CONTRACT CHANGE ORDER NO. _____
SHEET OF _____

PARTIAL GIRDER PLAN CABLE TRAY LAYOUT

DETAILS
SAS SUPERSTRUCTURE GIRDER WESTBOUND
TYPICAL TRAY AND CONDUIT INSTALLATION AT PIER W2W
SCALE AS NOTED

E-126

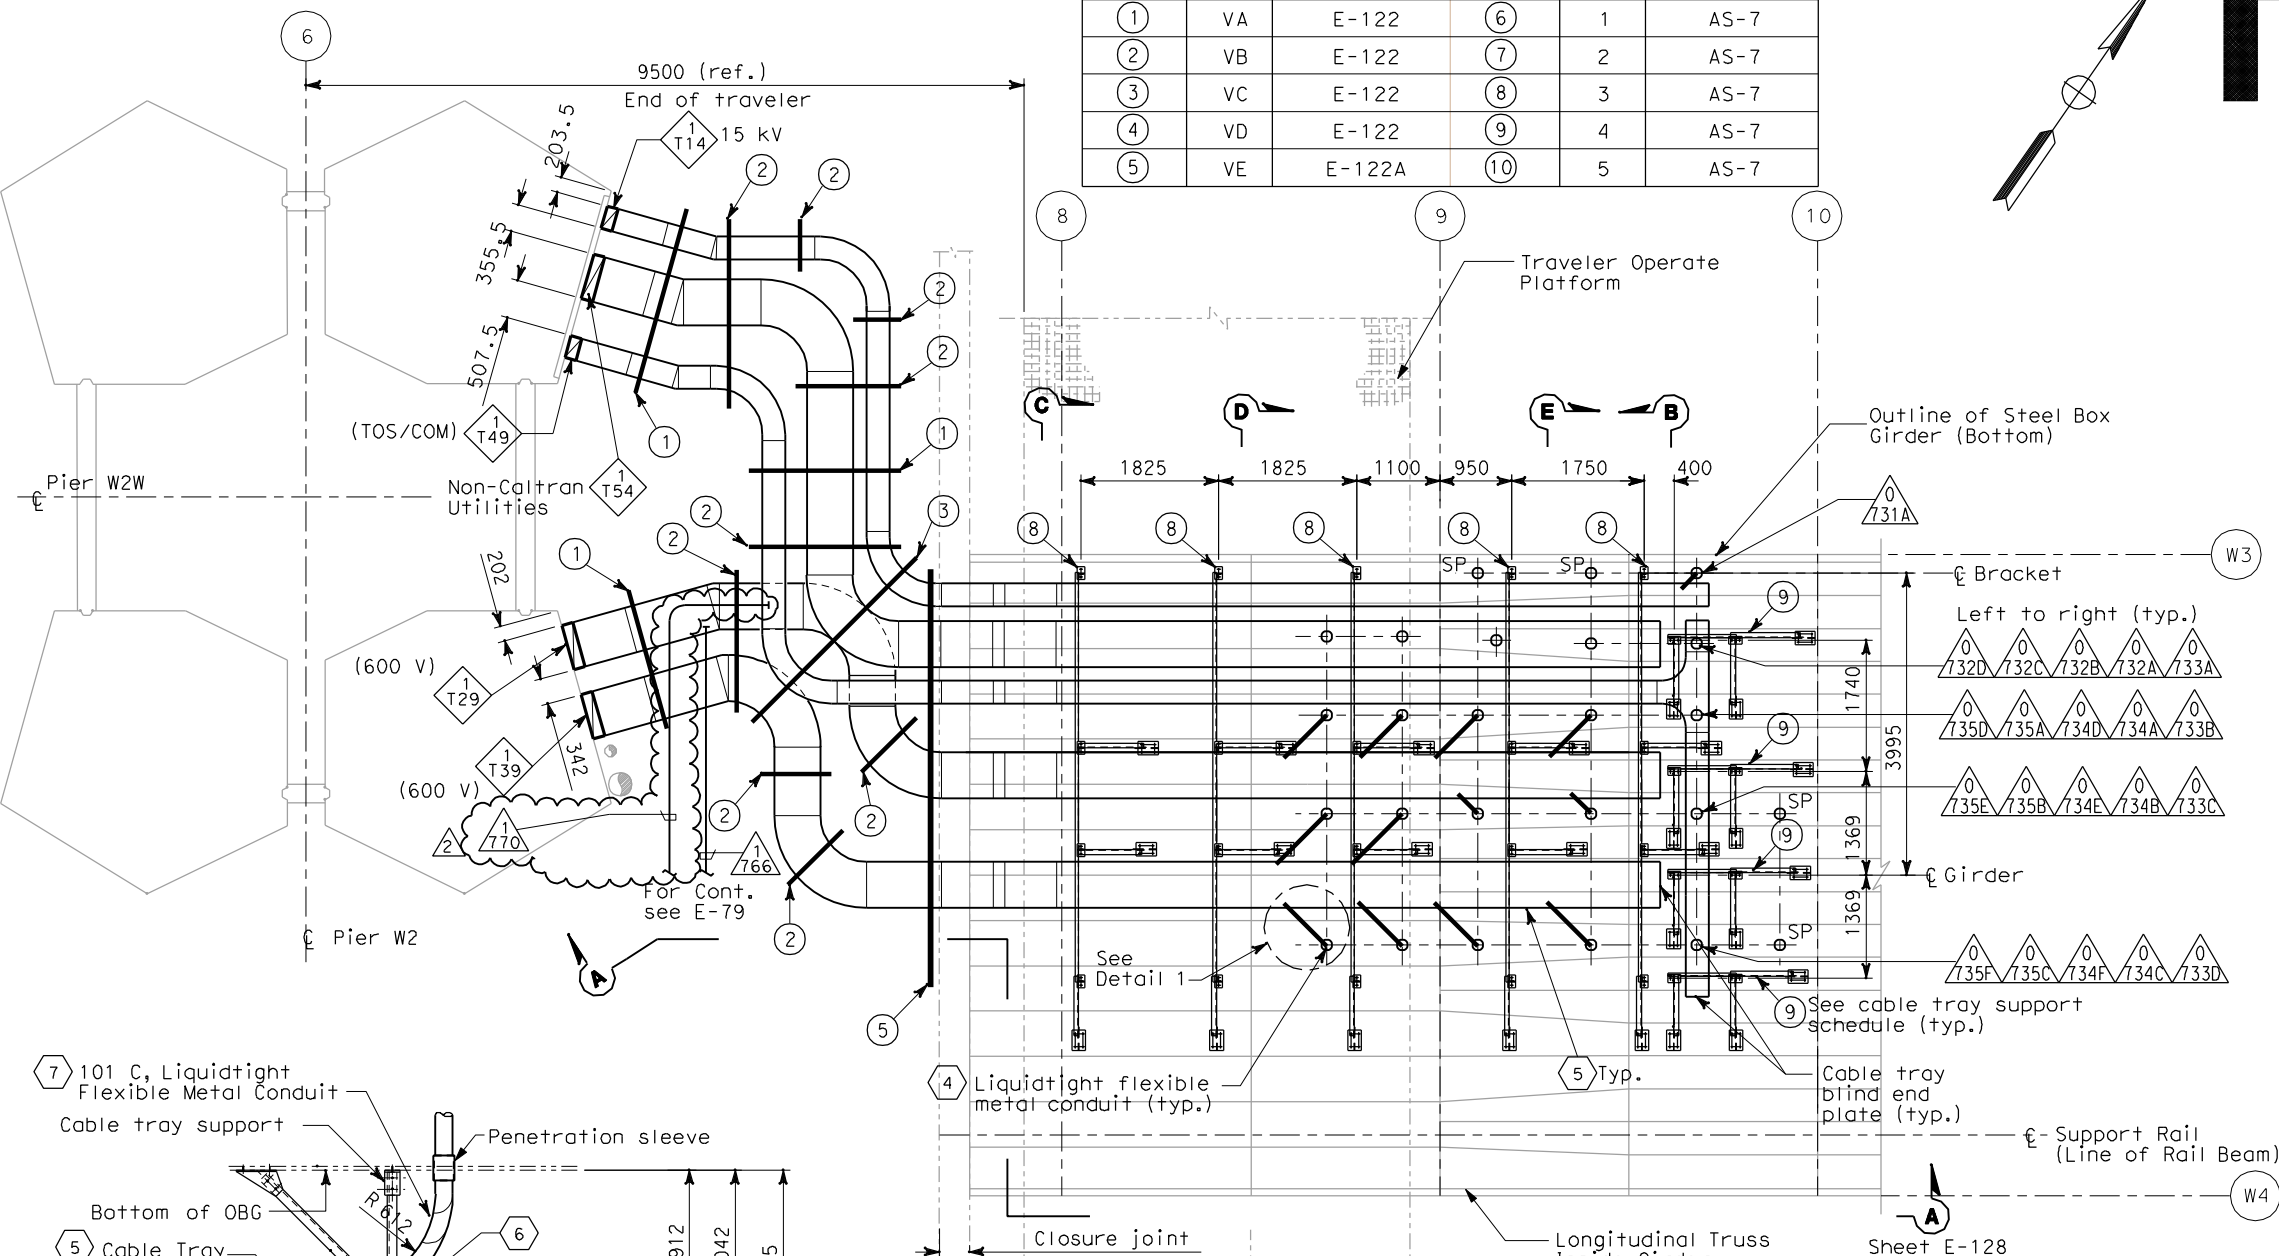
REQUEST FOR INFORMATION NOT ADDRESSED IN THIS CCO REMAIN IN FORCE								
	03/26/10	DEHUMIDIFIER SCADA INTERFACE				RR	RG FW	130
	02/25/08	CABLE TRAY CHANGES				RG	SE	42S
MARK	DATE	DESCRIPTIONS				BY	CH'D	CCO
REVISIONS
